Application for Works Approval Amendment

Works Approval Number W6490/2021/1

Premises Talloman Rendering Facility
Lot 115 Lakes Road
HAZELMERE WA 6055

Date of Report 18 October 2023

Figure 2: Two Lamella Clarifiers and associated platforms and staircases.

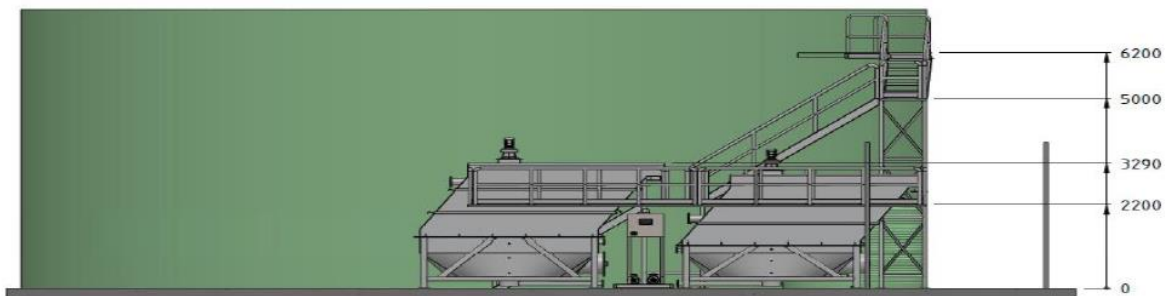
The amendment is for the installation of two 32m³/h Lamella clarifiers which operate in between stage 1 and stage 2 (see Figure 2 and 3) using inclined plates to remove fine sized particles from solution which then collect at the bottom of the clarifier at the collection hopper. The Lamella clarifiers are thought to be up to 20 times more efficient than conventional clarifier tanks. The existing clarifiers 1, 2, 3 and 4 are tank clarifiers and each have a capacity of 8.33m³/hour and will continue to operate in their current configuration relative to stage 2 of wastewater treatment. The new clarifiers will significantly increase the removal of biological loading between the two stages of treatment and improve the quality of final treated effluent from the BNR. Water will be of a higher quality reducing odour and will allow for greater water reuse on site.

Construction work will include the platforms and stairs around the two new clarifier tanks as shown in Figure 2. The works include associated pumps, pipe works and valves. The two new clarifier tanks will be located within the existing BNR footprint area.
